Memorandum

Subject: Expanded Groundwater Monitoring Scope,
Cabot Carbon/Koppers Superfund Site, Gainesville, FL

FIGURE 1
 MONITORING WELLS TO INCLUDE IN
 MARCH 2005 EXPANDED
 GROUNDWATER MONITORING EVENT

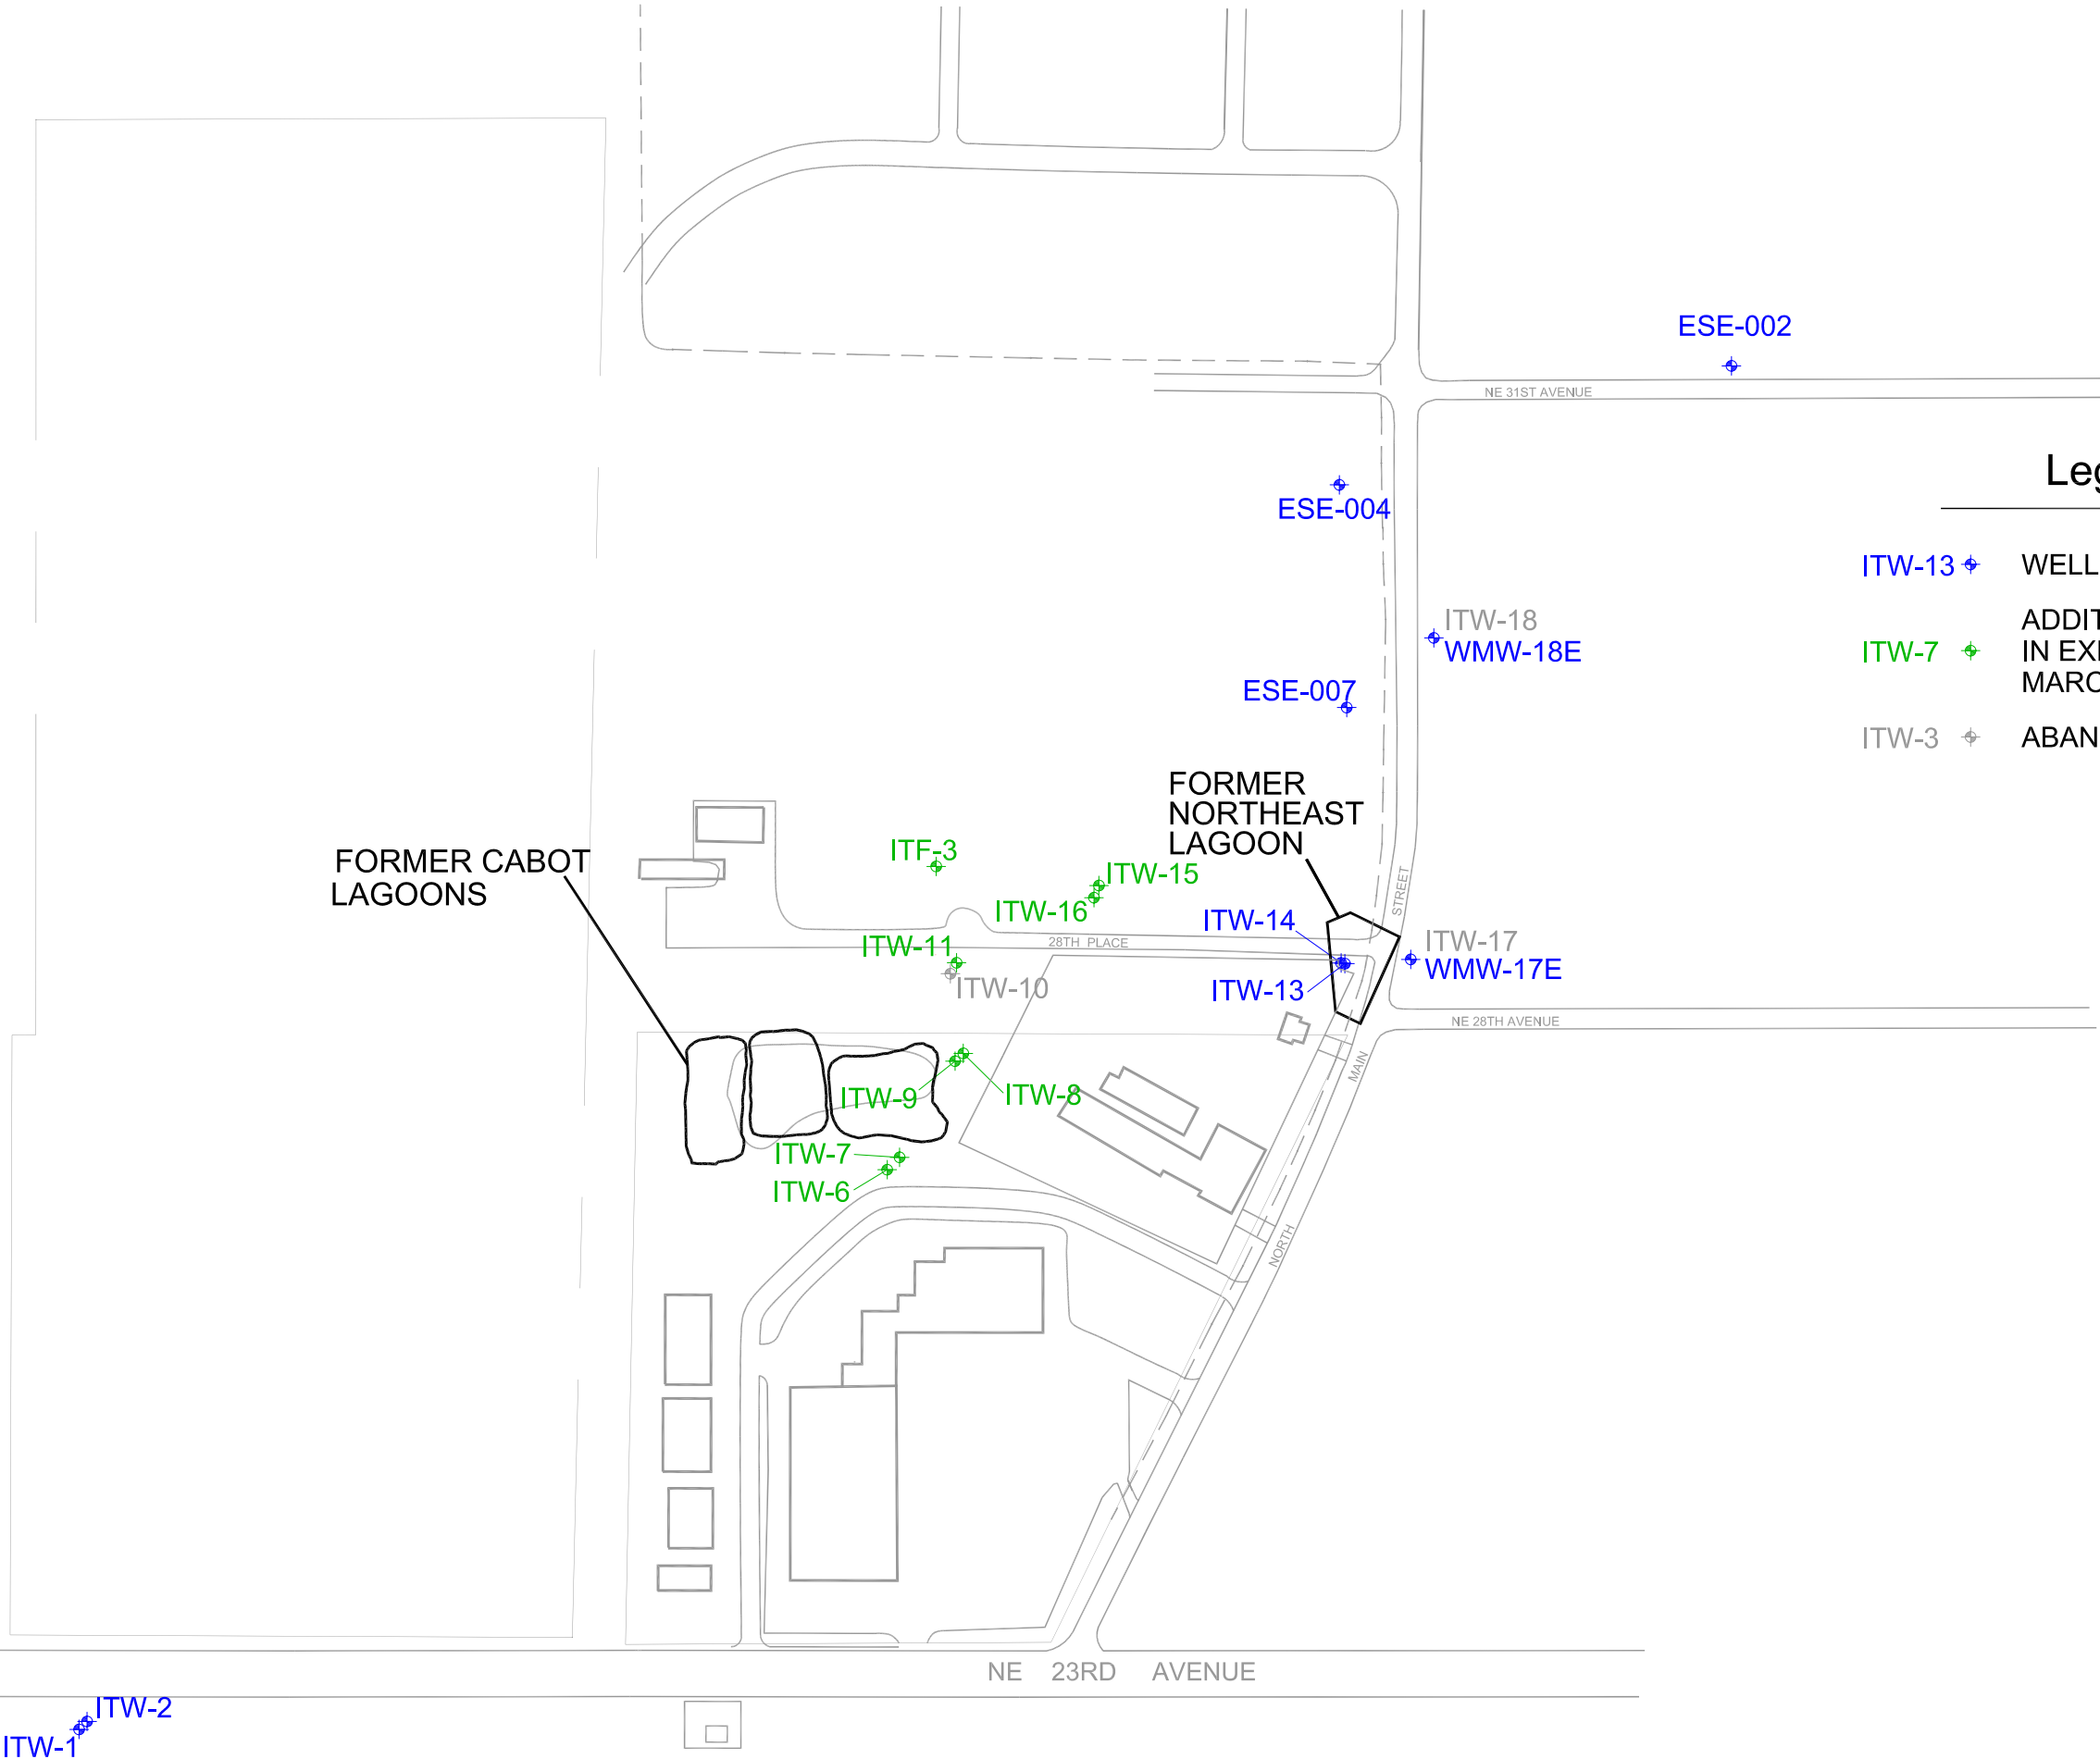
The above-recommended 8 additional wells were also included in FDEP's recommended expanded monitoring scope. The differences between Gradient and FDEP's recommended program scope are:

- *ITW-10*: This monitoring well was abandoned and hence is not available for sampling.
- *ITW-5*: Monitoring well, MW-23BR, which is located adjacent to ITW-5 and is screened essentially across the same depth interval (20-25 vs. 19-24 ft below grade) was sampled

by TRC on Beazer's behalf in April 2004. Wood-treating related compounds – volatile organic compounds (VOCs), polycyclic aromatic hydrocarbons (PAHs), and pentachlorophenol – were detected. Given the availability of these recent groundwater quality data, we do not believe that ITW-5 needs to be sampled at this time.

- *ITW-4, ESE-005, and ESE-006:* Located in the southern portion of the former Cabot property, where no Cabot-related sources were present. In addition, given the presence of other source areas that are believed to be affecting groundwater quality in this portion of the Site (leaking UST at Automasters, shopping mall parking lot, *etc.*), these wells would not produce data useful in characterizing groundwater quality near and downgradient of the former Cabot Lagoons.

- *ESE-003:* Located too far field from the former Cabot property. Monitoring well WMW-17E has been routinely sampled, and had demonstrated that the groundwater interceptor trench is operating effectively.

- *ITF-2:* Located near the Koppers facility and too far-field from the former Cabot property. In addition, this well was recently (April 2004) sampled by TRC on Beazer's behalf.
